# 2793 – 151 Shaftesbury Avenue, Response to LB Camden Drainage Officer Comments

Job no. 2793

This note provides a response to comments received from London Borough of Camden's (LBC's) Drainage Officer on the planning application, received via email dated 19.12.24, via DP9 Ltd, and subsequent discussions with LBC Case officer and DP9 Ltd.

**Image 1 – Environment Agency NaFRA2 Surface Water Flood Risk - 30.01.2025**

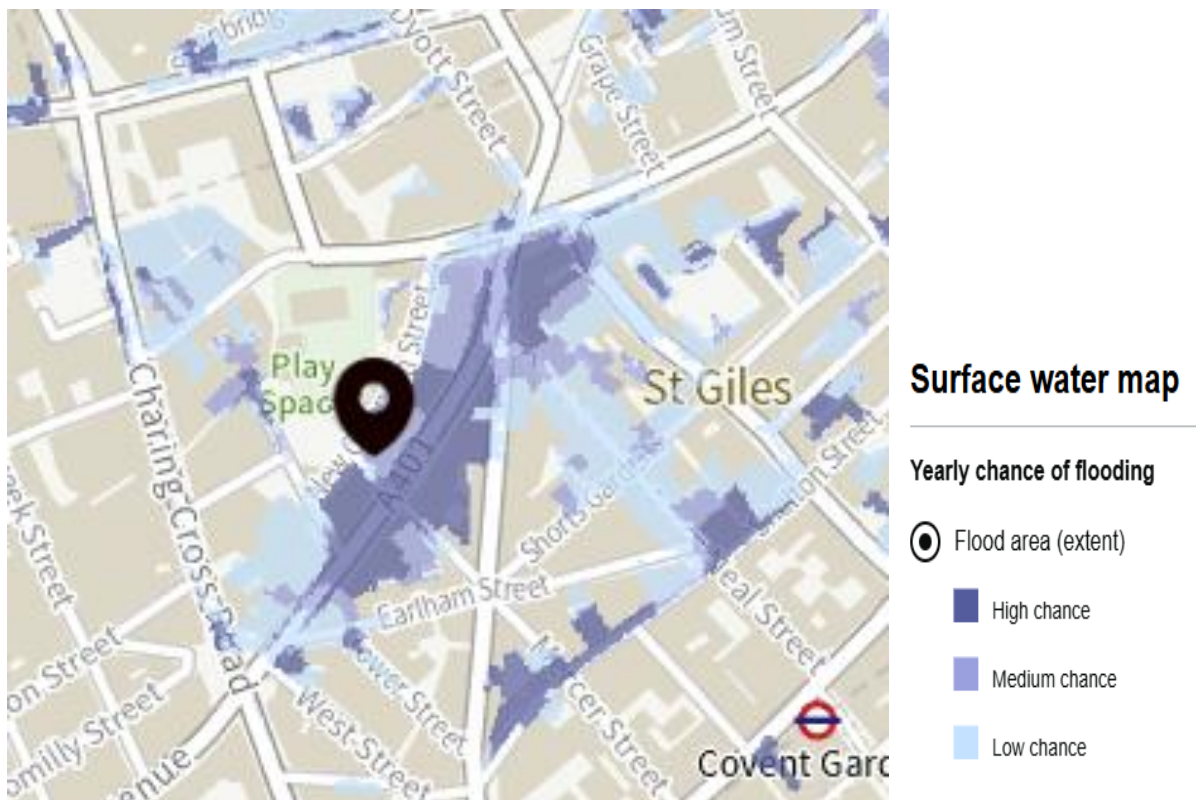
The Flood Risk Assessment submitted in support of the application provided an assessment of surface water flood risk based on the available flood mapping data available at that time.

The proposed development involves an extension at roof level while retaining the ground floor arrangement as existing, therefore it is considered that the risk profile for the building itself remains largely unchanged.

Post-submission, and only very recently on 28<sup>th</sup> January 2025, the Environment Agency has released the New National Flood Risk Assessment (NaFRA) 'Risk of flooding from rivers and sea' and 'Risk of flooding from surface water' data.

An extract below in Image 1 shows the NaFRA surface water flood risk mapping at the proposed site's location.

However, recognising the newly published data and the importance of ensuring appropriate mitigation measures are in place, particularly in relation to the basement and any plant equipment is acknowledged.

It is proposed that temporary flood barriers will be utilised as mitigation measures as part of a management system. The proposal is providing an improvement against the baseline position.
